Subject: Blackbuck Resources, LLC; Independence SWD #1 (SWD-2676; pEG2528350873)
C-108 Supplemental Submittal

The purpose of this letter is to submit supplemental information associated with Blackbuck Resources, LLC's (Blackbuck) C-108 application for the proposed Independence SWD #1 (SWD-2676; pEG2528350873). This information is being provided to address OCD's comments in a recent Administrative Completeness Checklist. A list of the updates to the application is included below.

Proposed SWD Data and Wellbore Diagram

Proposed Wellbore Diagram

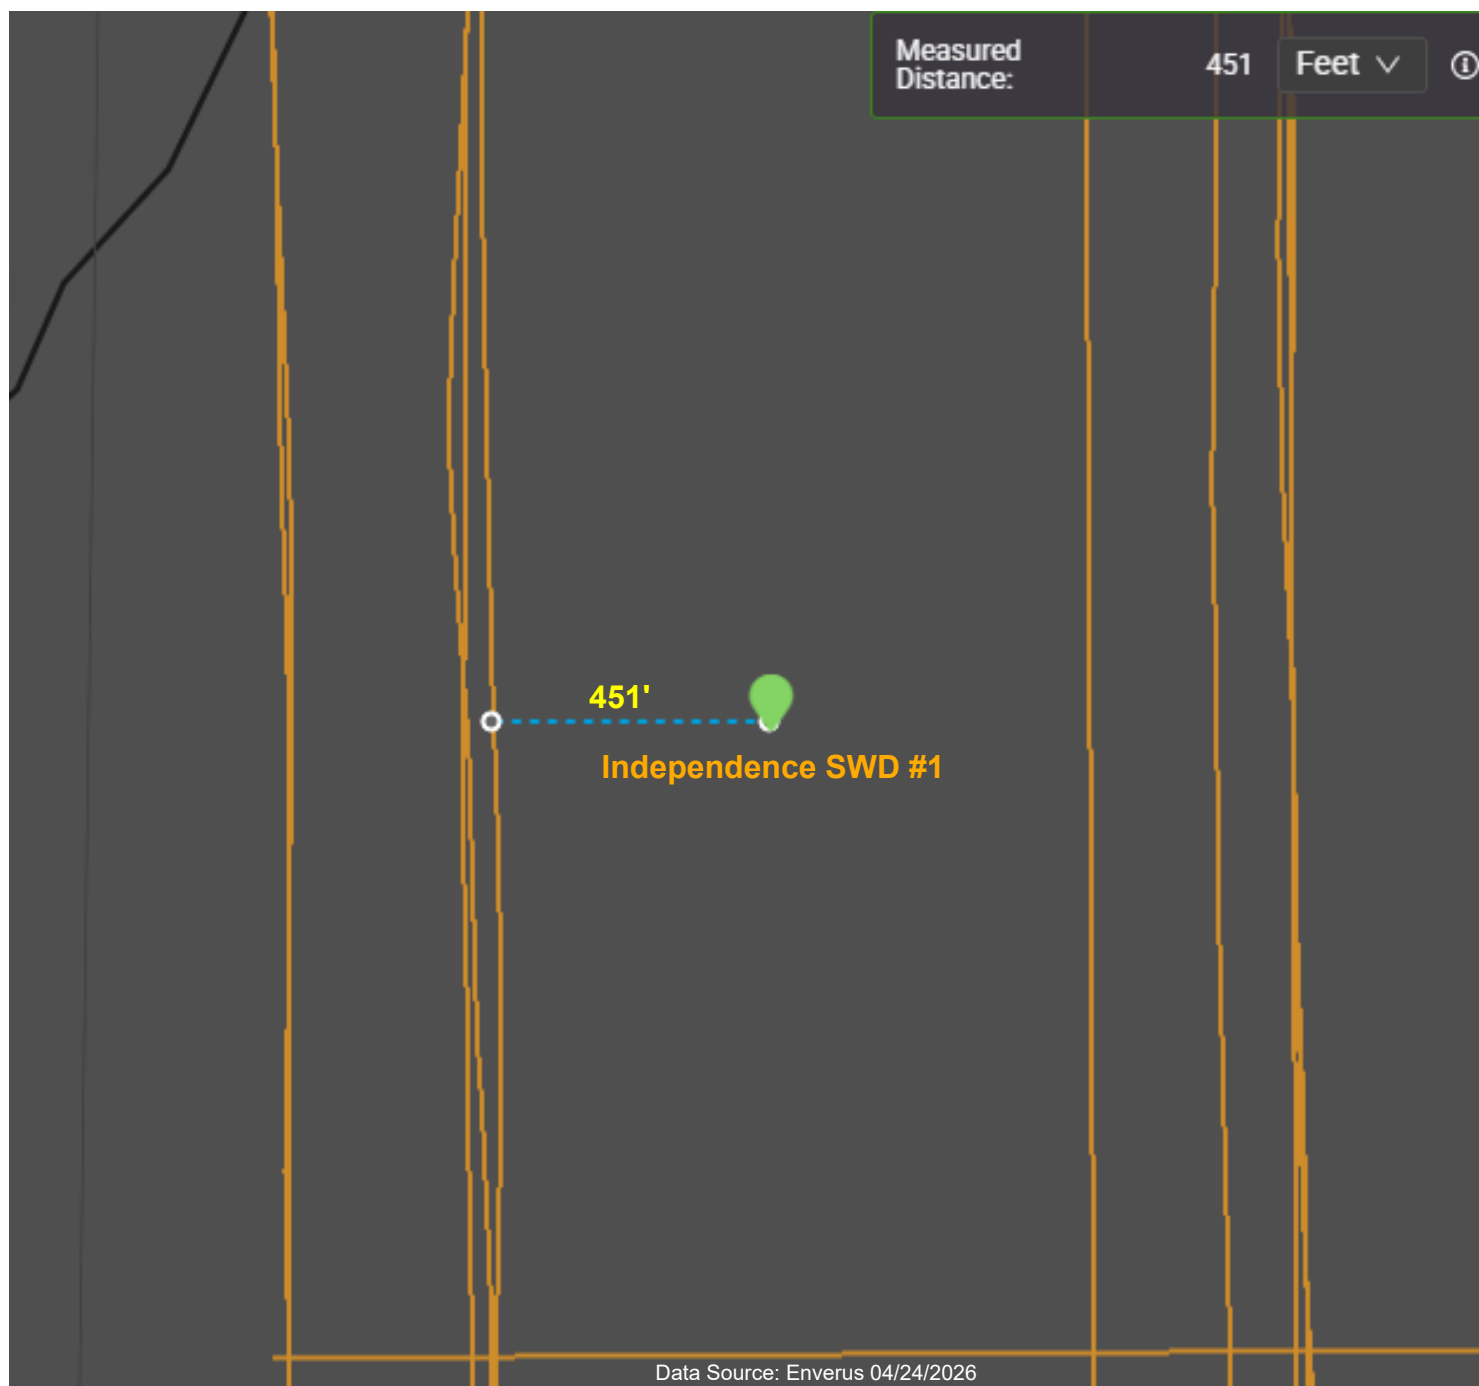
- **Revise from Open-Hole to Cased-Hole:** Revised completion from Open-Hole to Cased-Hole and updated the liner depth and cement volumes in the Tabulated Casing Data and Wellbore Diagram (WBD) accordingly.

- see **Attachment A** for Updated Tabulated Casing Data (p. 3) and Updated WBD (p. 5)
- **No Underlying USDW Statement:** Added a Statement to the Geology Data clarifying that "No USDWs were identified underlying the proposed injection interval."

Casing Size: 7-5/8 in
Casing Type: 29.7 lb/ft HCL-80
Casing Depth: 9,344 ft – 13,672 ft
Hole Size: 8-3/4 in
Top of Cement: 9,344 ft
Sks Cement: 318 sx
Cement Type: Class C

Formation(s): Devonian-Silurian
Top: 12,351 ft
Bottom: 13,672 ft
Hole size: 7-5/8 in
Cased or Open-Hole: Cased-Hole
